Our Reference: P\_21\_19\_APP\_Mamre\_WAD\_DD

**Subject: Access Logistics Park – 884-928 Mamre Road, Kemps Creek – Access Road**

In regard to the email you sent on 16 February 2023 with subject "Access Logistics Park - Meeting Minutes for the 08.02.2023", we have outlined below our responses to the actions and comments made by TfNSW.

**Annexure 4 – Land Dedication Plan *Nettleton Tribe Drawing 11213\_DA010 P10***

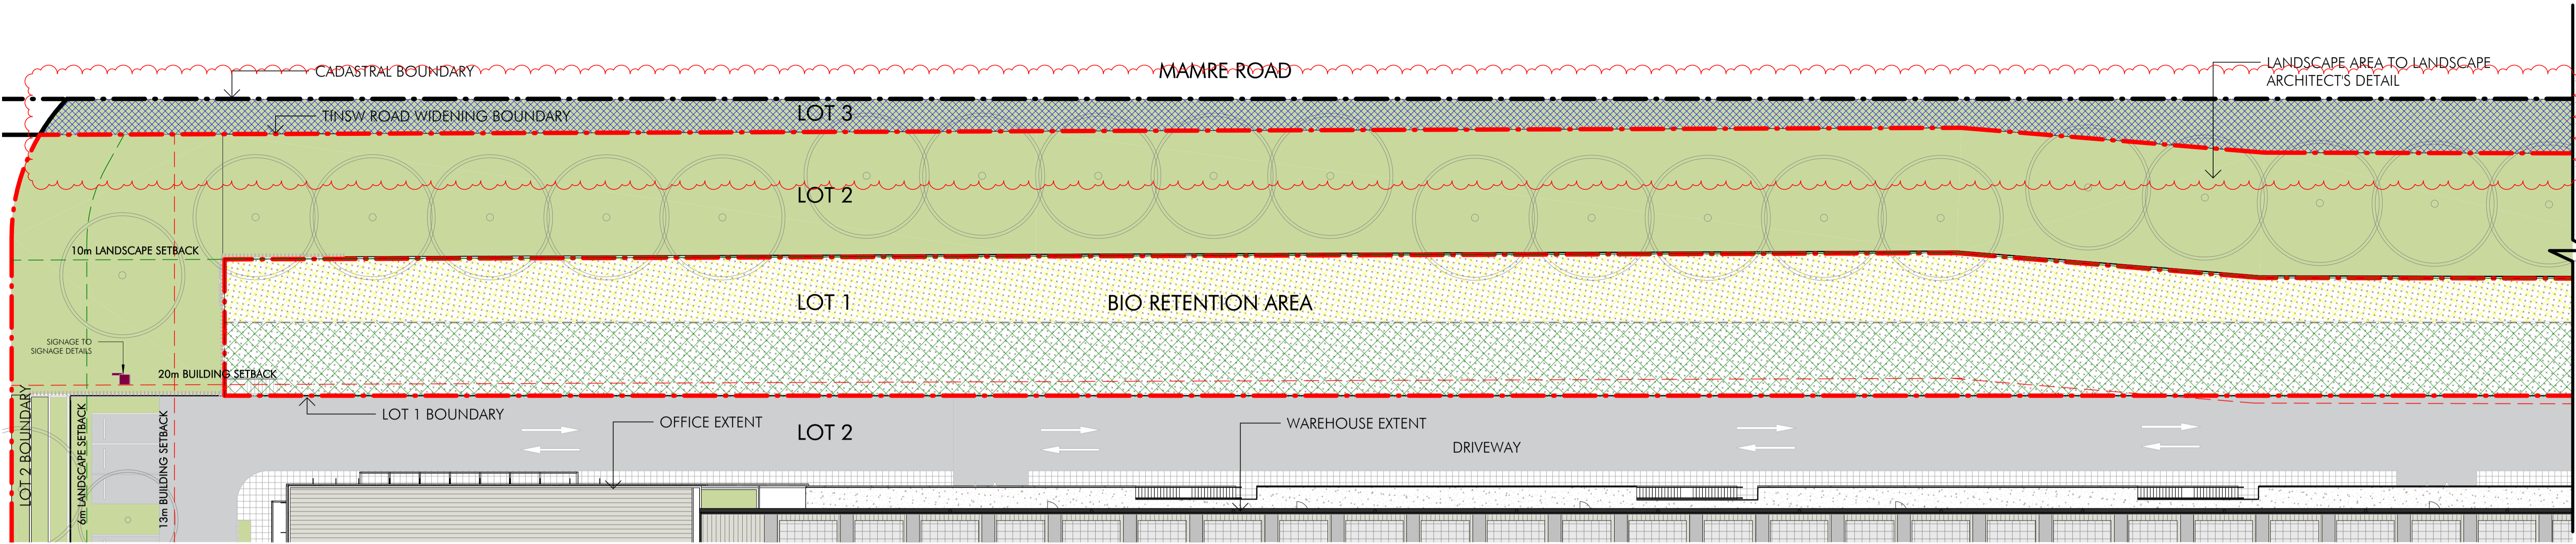
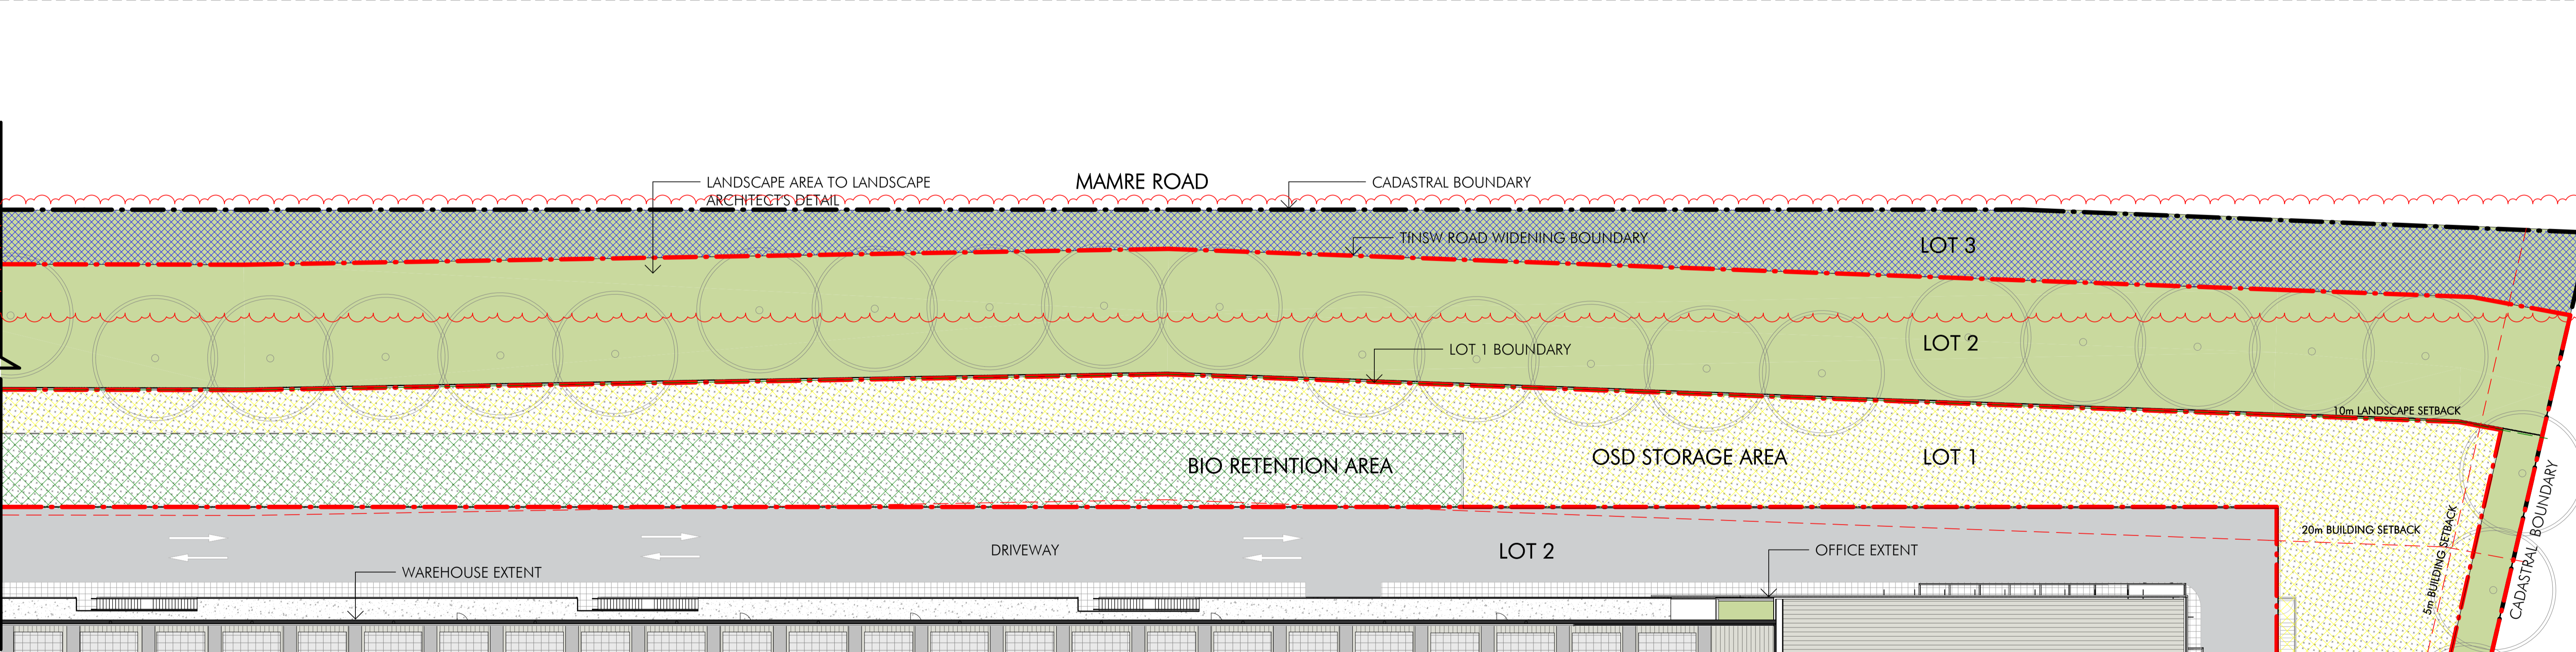
4. Identification of additional land adjoining the deceleration lane for future road upgrades.
- a. Action (Applicant): The Applicant is advised to identify and provide revised plans that detail the available land for future road widening (3.5m shoulder). The plan set should include a long and wide section demonstrating the potential for future land dedication.

Altis as part of its SSDA are proposing to dedicate approximately 1,481 square meters of land fronting their site for road widening in accordance with TfNSW Ultimate Mamre Road Design. This land is shown hatched in Blue within *Nettleton Tribe Drawing 11213\_DA010 P10* and is contained within Annexure 4.

Altis as part of its SSDA are proposing to dedicate approximately 1,481 square meters of land fronting their site for road widening in accordance with TfNSW Ultimate Mamre Road Design. This land is shown hatched in Blue within *Nettleton Tribe Drawing 11213\_DA010 P10* and provided in Annexure 4.
